Office Action Summary	Application No. 10/520,463	Applicant(s) DI TRAPANI, AGOSTINO	
	Examiner Jessie Fonseca	Art Unit 3637

DETAILED ACTION

Fig. 3: Khamis (US 6,050,749)

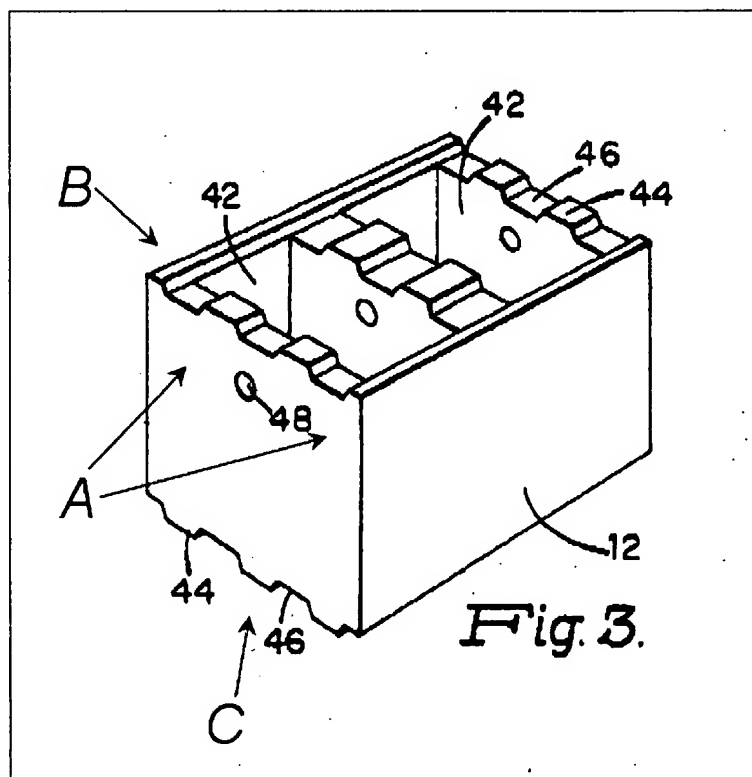
With regards to claim 38 and 41: Khamis discloses a wall (fig. 2 and 6) constructed from a plurality of construction elements (12) made of concrete like material (col. 3, lines 41-46), each construction element (12) comprising an upper face (B), a lower face (C), and lateral faces (fig. 3), the construction element (12) comprising at least one groove (46) extending over the upper face (B) thereof, the groove (46) being associated with a load-bearing wall or partition (A) of the construction element (12) and arranged at a distance from an outer lateral edge of the construction element (12), the construction element (12) further comprising at least one protuberance (44), which extends over the lower face (C) thereof, the protuberance (44) being arranged in such a way that when a first construction element (12) of the plurality is superimposed on a second construction element (12) of said plurality within said wall, the protuberance (44) of the first construction element (12) extends in the groove of the second construction element (12) (fig. 6).

With regards to claim 39 and 42: Khamis, in view of Breaky or Stewart Jr., further discloses the protuberance (44) and the groove (46) have a cross-section, which is approximately trapezoidal in shape (fig. 3), in such a way that, a protuberance lateral flank of the first construction element (12) extends approximately parallel to a groove lateral flank of the second construction element (12) (fig. 3 and 6), and a small base of the trapezoid of the protuberance (44) being arranged opposite a small base of the trapezoid of the groove (46) when they are engaged (fig. 3 and 18). As per the modification of claim 37, the lateral flanks are arranged in such a fashion as to have first space between them, in which a binder is disposed within, the small bases being arranged in such a way where binder is disposed in the second space as created by the grooves.

With regards to claim 45: Khamis, in view of Breaky or Stewart Jr., further discloses the width of the groove (46) of the construction element (12) is less than the thickness of the load-bearing wall or partition (A) of the construction element (12) (fig. 3).
